Amendment NO.3

SUBJECT: USC-IFB-3257-DG/ Furnish, Deliver and Install Exercise Equipment and Flooring for University of South Carolina, Blatts P.E Center

DATE: March 8, 2018

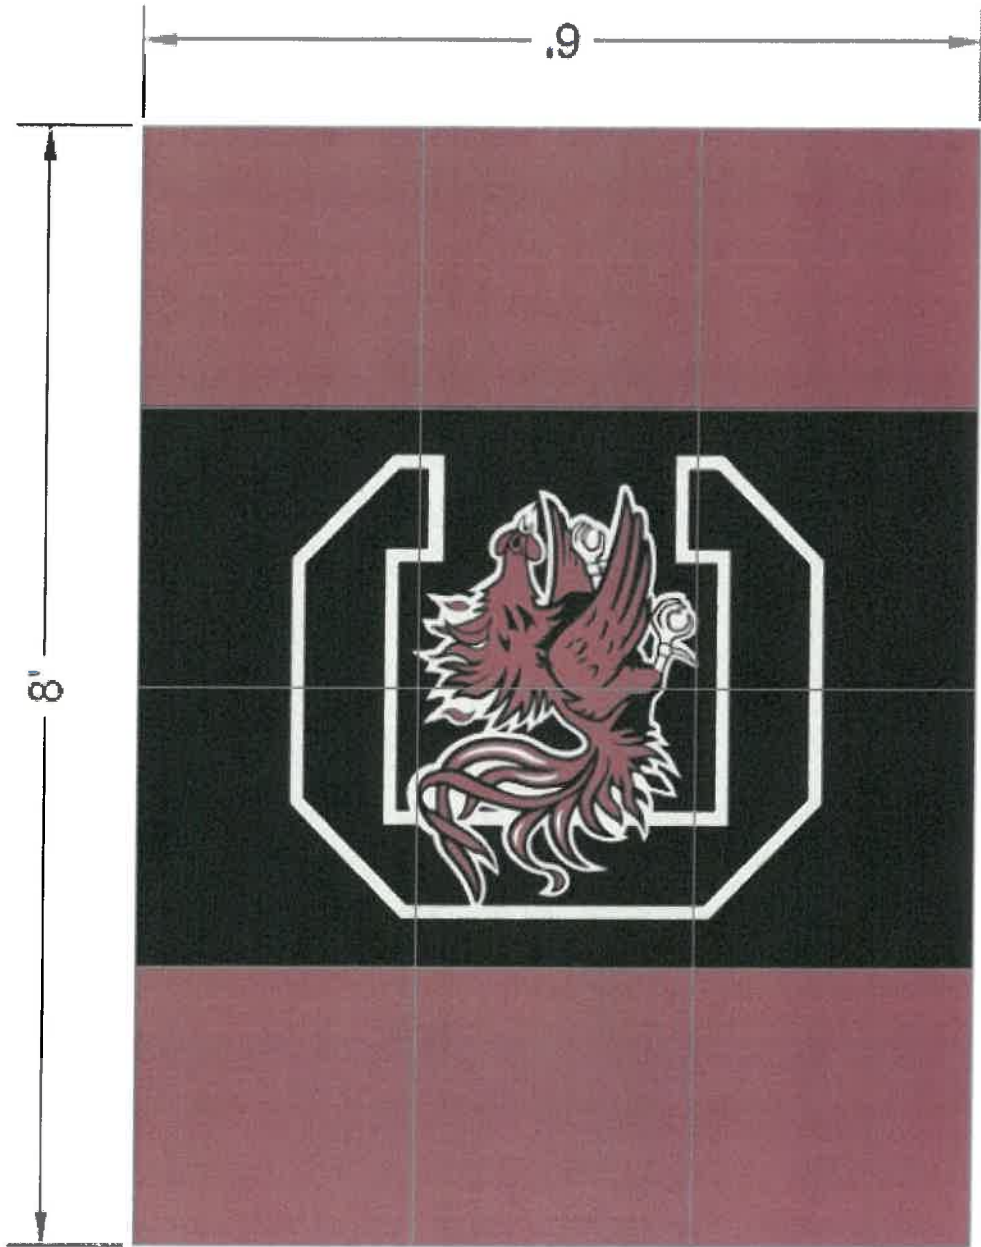
Question: Can you provide a jpeg or pdf of the logo?

Do you want the logo in the Smash Tile or Rally Roll?

Answer: attached.

Answer: The logo is in the smash tiles.

- 1102 EGGHELL
- 1820 MAROON RED
- BLACK
